Construction Division
Additions & Alteration Charges Approval Form

GULMOHAR RESIDENCY

Details of Additions & Alterations

Flat No	306	Block no.	' F '
Flat Area	1360 sft	Type	Deluxe / Luxury
Buyer Name	Mrs.T Vaishnavi/ Mr.Srujan		
Phone No.	8885679877	Email

F-306, Electrical / GMR.

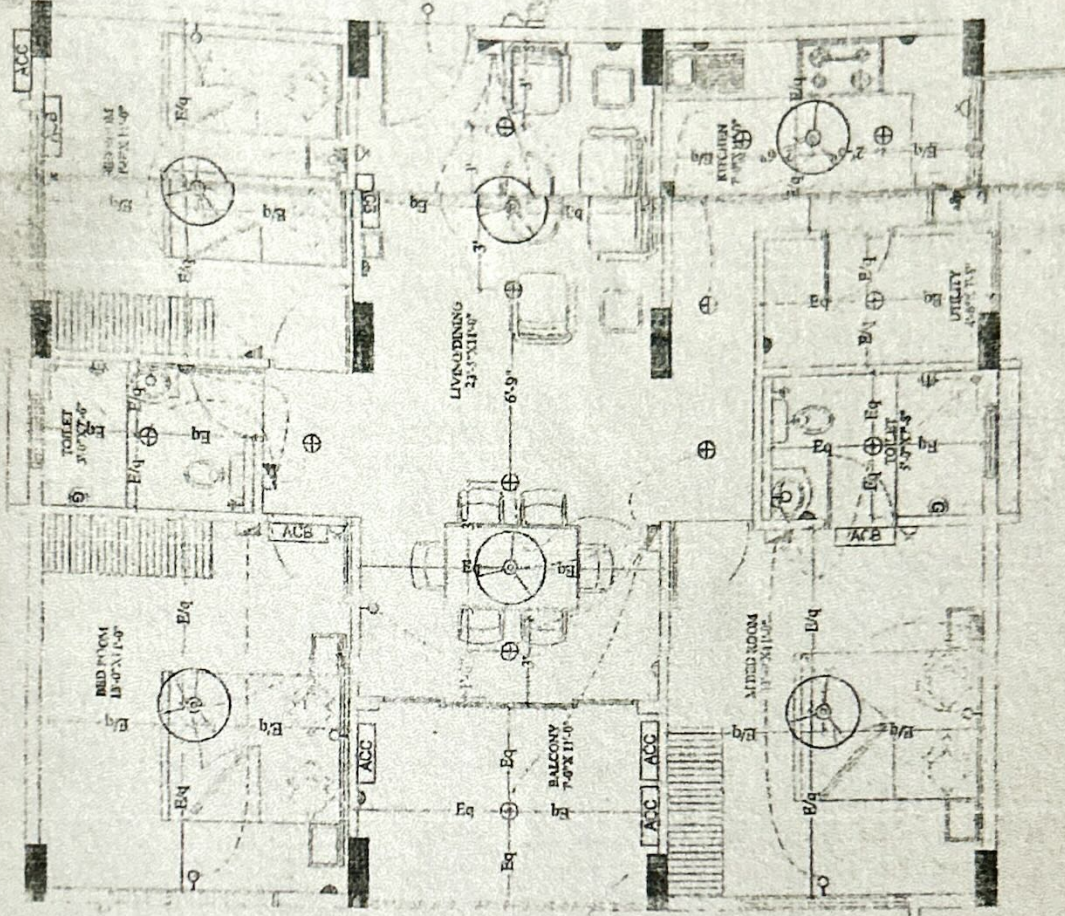
Changes in electrical points: (mark on plan)

Description	Direction	Owners & Developers	Date	Promoted by
WORKING PLAN-1360 S/A-1 TYPE	N	Modi Realty Mallapur LLP Project Name & Phase	25/09/2020 Jaya Pritha Soham Modi	Modi Properties Pvt Ltd

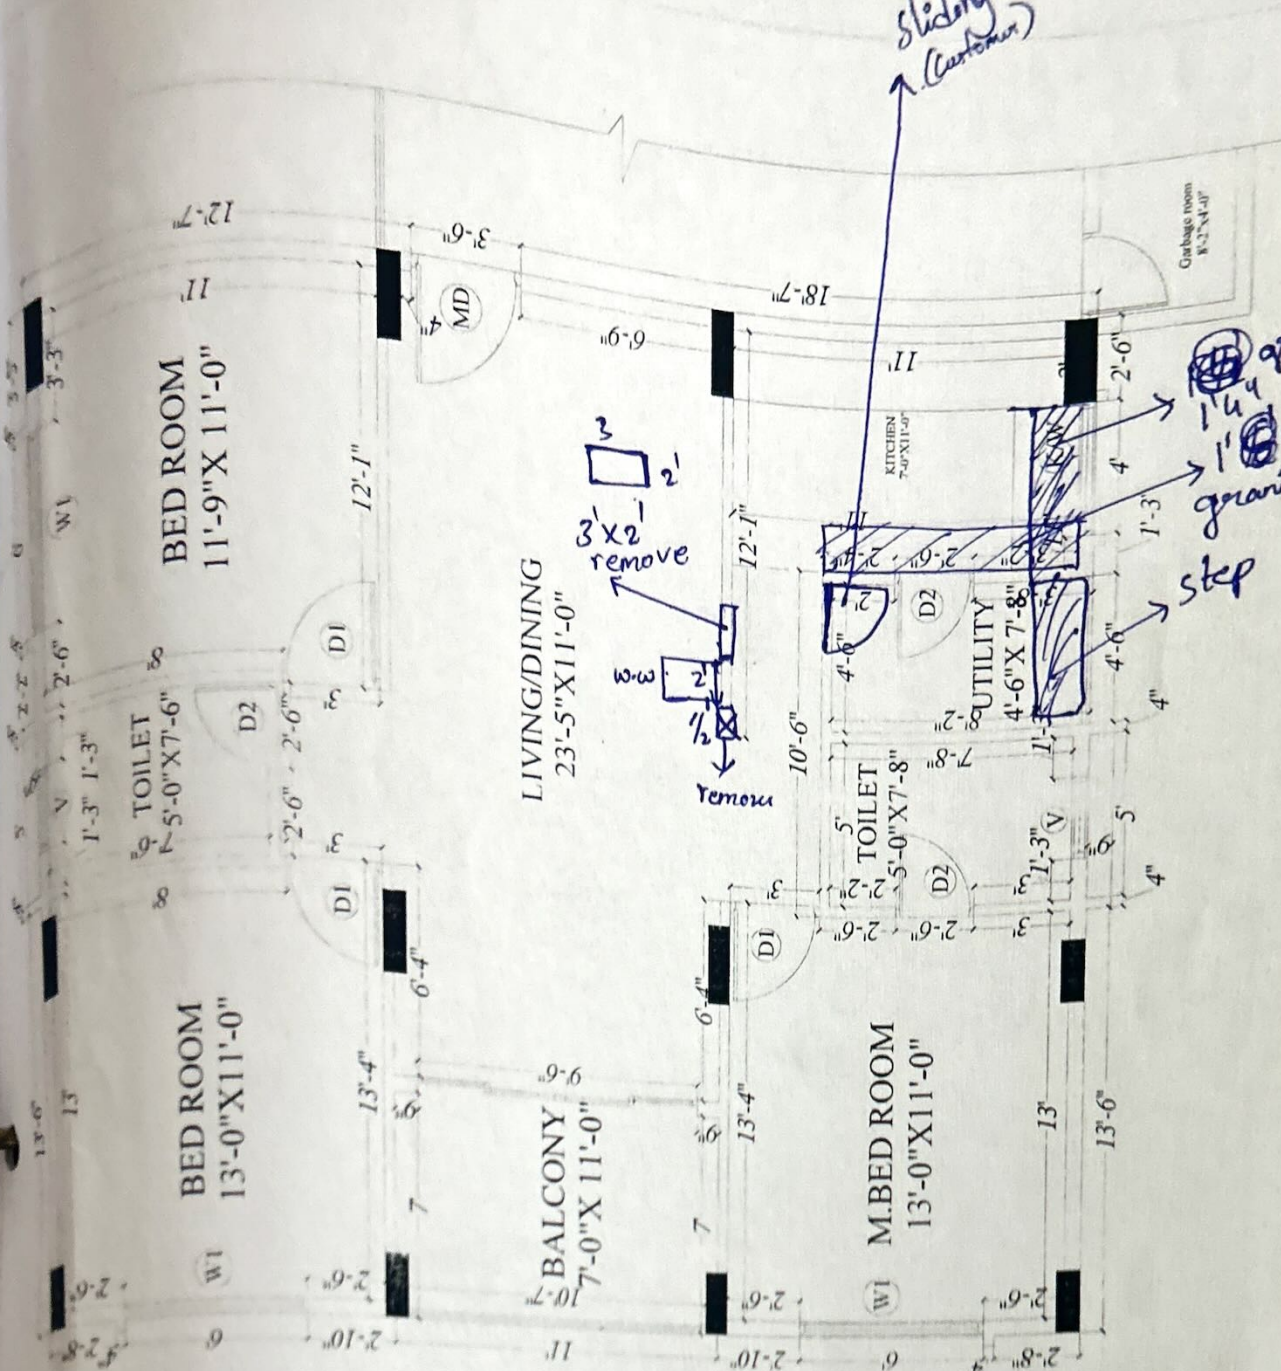
Changes in kitchen platform: (mark on plan)

Need Double Sink (~~vegetable sink~~).

customer goes to modular kitchen.
(as option)
